# Building R4B Barangaroo South Modification 2

State Significant Development Modification Assessment  
(SSD 6965 MOD 2)

December 2020

**Figure 5 |** Amendments to the ground floor residential lobby (Base source: Applicant's Design Report)

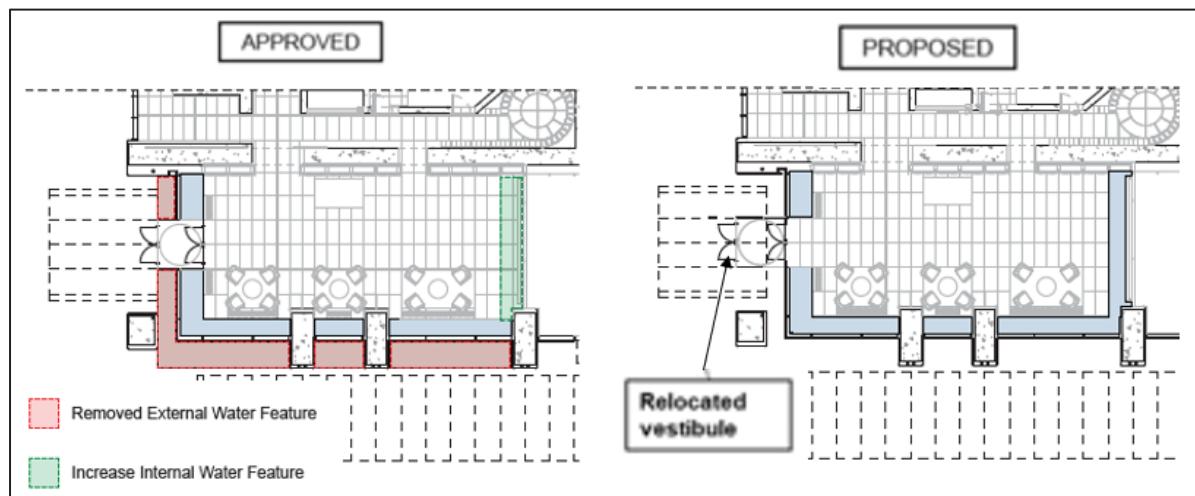
Issue	Consideration	Recommendation
Residential lobby	<ul style="list-style-type: none"> <li>The modification proposes amendments to the residential lobby (<b>Figure 5</b>) including removal of the external water feature, enlargement of internal water feature, relocation of the entry vestibule and minor internal amendments.</li> <li>The internal water feature has been enlarged to wrap around three sides (rather than two sides) of the lobby to improve the continuity of the design. The entry vestibule has been redesigned in response to the changes to the external/internal water features.</li> <li>The Department considers the proposed amendments are minor and notes they would match those recently approved within neighbouring building R4A (<b>Figure 2</b>).</li> <li>The Department concludes that revised water feature would maintain the high design quality of the residential lobby and the internal amendments would improve general circulation within the podium and are therefore acceptable.</li> </ul>	The Department recommends the list of drawings be updated to reflect the changes.

**Figure 6** | Reversal of two and three-bedroom apartments LB-05 and LB-06 (levels 1-19 and 21-32) and MB-04 and MB-05 (levels 33 – 46) and revised location of DGUs (Base source: Applicant's Design Report)

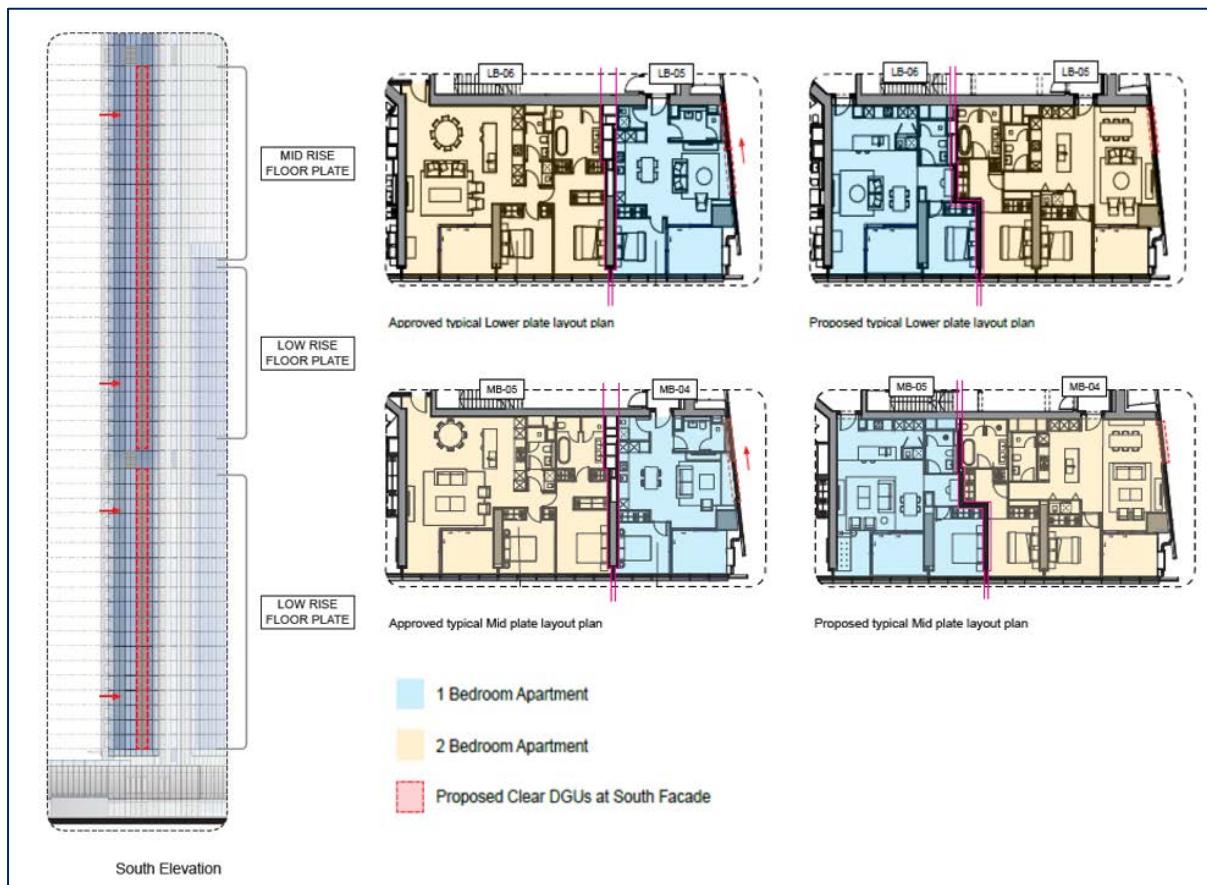
The amendments to the one and two-bedroom apartments (LB05 and LB -06) across levels 1 to 9, results in dual aspect naturally cross ventilated two-bedroom apartments and single aspect one-bedroom apartments (**Figure 6**). However, this also results in the ventilation duct needing to be extended further into the building to reach the relocated one-bedroom apartments.

The Applicant notes that the previously approved ducted ventilation would no longer be a practical option for improving amenity and seeks to delete the duct as:

- the increased length and additional bends required to reach the relocated one-bedroom apartments require a larger duct (minimum 1.2m x 0.45m) to maintain adequate airflow performance
- extending a duct of the requisite size would result in a loss of amenity including reduced ceiling height in the lobby and kitchen and loss of space within the bathroom, study, bedroom and storage for the one-bedroom apartment.

The Department notes that the proposed modification does not reduce the number of naturally ventilated apartments (50%). It has carefully considered the revised apartment layout on levels 1 to 9 and considers the removal of the ducted ventilation solution for the additional 17% (nine x 1-bedroom) apartments is acceptable as:

- the relocation of the two-bedroom apartments is consistent with the objectives of the ADG which provides that larger apartment types should be located on corners where more building frontage is available
- the two-bedroom apartments which accommodate more residents, will now benefit from natural ventilation, greater daylight, and enhanced views due to the dual aspect
- two additional open cavity façade glazing bays are provided to the one-bedroom apartments, increasing the opportunity for natural light, ventilation and views
- more useable and functional layouts can be achieved for both the one-bedroom and two-bedroom apartments in their revised locations
- all apartments which do not benefit from natural ventilation are considered to offer a good standard of amenity, including excellent outlook and access to daylight.

The Department considers that the revised location of the one and two bedroom units results in an improved amenity outcome compared to the approved layout and that the benefits of extending the ventilation duct to the new one-bedroom apartment location would be outweighed by the impacts to internal amenity and circulation of both one and two-bedroom apartments.

**Figure 7** | Reconfigured apartment layout at levels 48 to 55 from two x 4-bedroom and one x 3-bedroom (left) to two x 3-bedroom and two x 2-bedroom (right) (Base source: Applicant's Design report)

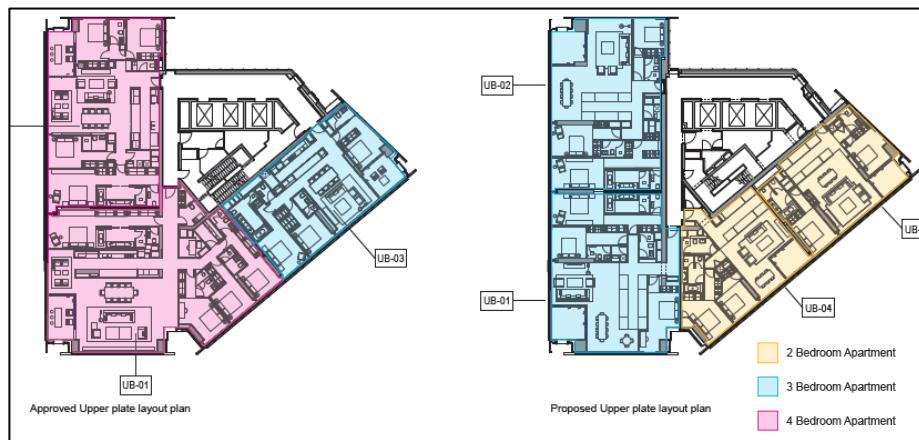
The proposed modification would reduce the number of apartments receiving 2 hours of direct sunlight from 65% to 63% and increase the number of units which receive no sunlight from 16% to 18%. The reduction in the number of apartments meeting the 2-hour solar access guideline is a result of the amendments to levels 48 to 55 which provide eight additional 2-bedroom apartments located on the western façade which do not meet the minimum ADG requirements (**Figure 7**).

While the proposal would result in a smaller percentage of apartments meeting the recommended solar access provision, the Department considers this is acceptable in this instance as:

- this modification increases instances of non-compliance by only 4% (8 affected apartments in total)
- when considered across the 9am – 5 pm period (as was considered acceptable in the assessment of the approved development) 80% of apartments receive in excess of 2 hours sunlight and 99% receive some sunlight, mid-winter
- the affected apartments otherwise retain a high level of amenity including good access to daylight, generous floor space exceeding the ADG, up to 3 m ceiling heights, excellent outlook, and expansive views.
- the building is located in the Sydney CBD in close proximity to other tall buildings, where solar access is generally constrained.

**Figure 9** | Façade modifications at levels 48 to 55 (Base source: Applicant's Design report)

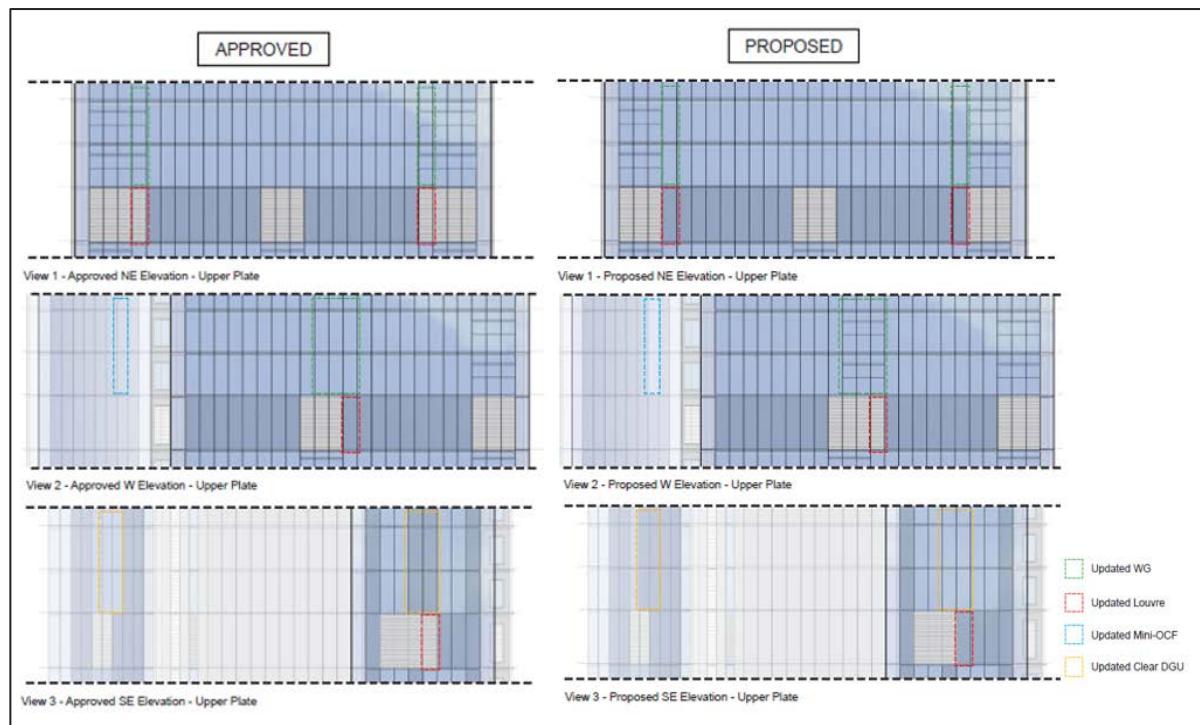
External alterations	<ul style="list-style-type: none"> <li>Amend wintergarden glazing and fixed double-glazed units (DGUs) to reflect the revised internal arrangements at level 48 to 57 (<b>Figures 9 and 10</b>)</li> <li>Relocate DGUs on the south façade of floors 2-19 and 21 – 46 to reflect revised internal layouts (<b>Figure 6</b>)</li> <li>Replace the open cavity façade (OCF) windows on the north-eastern elevation at podium level 2 with DGUs with external transom and relocate blinds to the internal face of windows (<b>Figure 11</b>)</li> <li>Amend the design of the glazed façade panels located at the top of the tower and residential lobby at podium level 2 (<b>Figures 12</b>)</li> <li>Raise lift core façade glazing from level 35 to 37</li> <li>Remove two louvred panels on the south facing podium façade (Figure <b>13</b>)</li> <li>Amend car park entrance width and recess door (<b>Figure 14</b>)</li> </ul>

The Department has considered the proposed external façade changes and is satisfied that the building will continue to exhibit design excellence as:

- the proposed materials and finishes are consistent with the existing approval
- the amendments to glazing panels, wintergardens and plantroom louvres have been carefully considered to maintain alignment between adjacent levels and retain the architectural rhythm of the façade
- the amendments would not alter the bulk, scale or height of the building and would maintain the architectural design integrity of the façade
- changes to the podium water feature and residential lobby would maintain the approved design quality and improve general circulation within the podium (**Section 5.3**).
